Technical Service Bulletin: TSB220149

Campaign 4915: Loose or Missing Bolts on C70D2RE - C275D2RE Rental Trailers

Figure 2. Trailer bolt locations for the C70D2RE/C100D2RE generator sets. It has a total of 8 bolts.

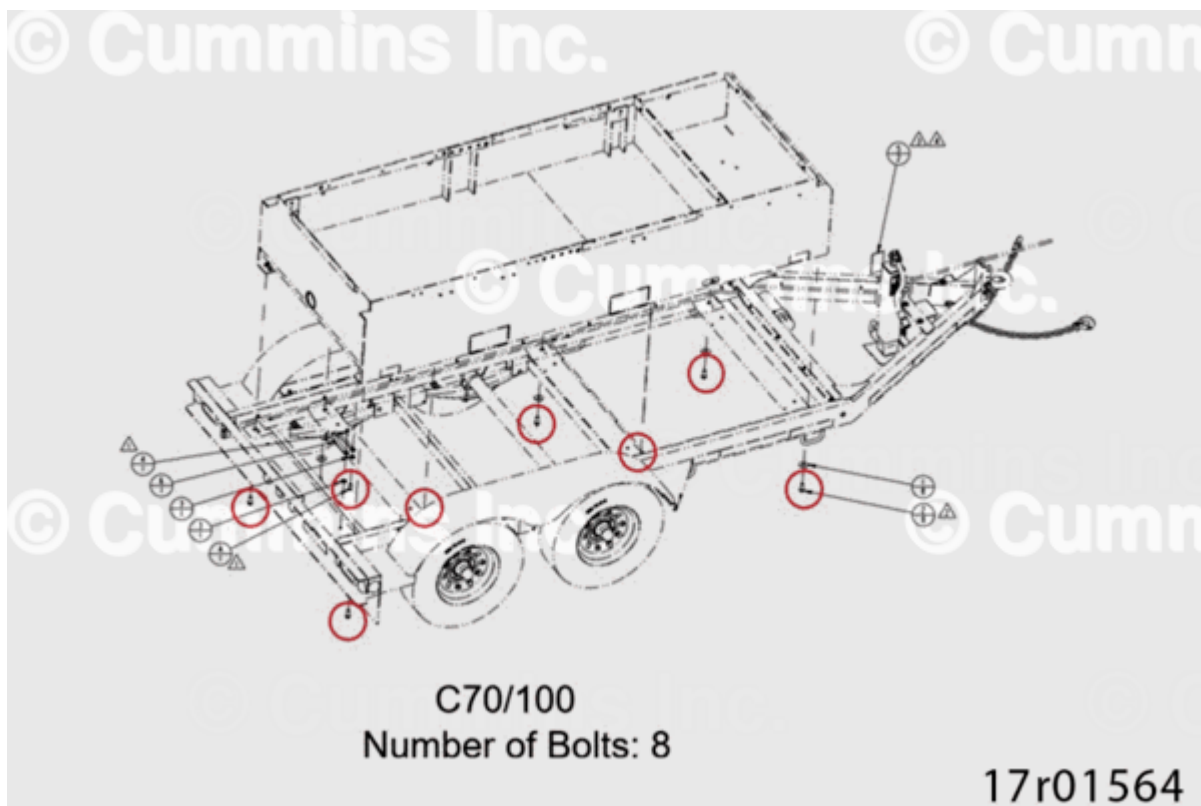
- Replace the missing bolts, nuts and washers at the locations shown in Figures 2-4 with the hardware specified in Table 1 for each generator set. Refer to the service availability section for Table 1.

- Torque bolt to spec as specified in Table 1 row "Torque Without Loctite".
- Optional: If the customer requests that Loctite be added, clean the new bolt threads thoroughly, then apply Loctite 248.
- Optional: After applying the Loctite, torque bolts to spec within the fixture time frame (5 minutes). Use the torque spec values shown in table 1 row "Torque with Loctite".
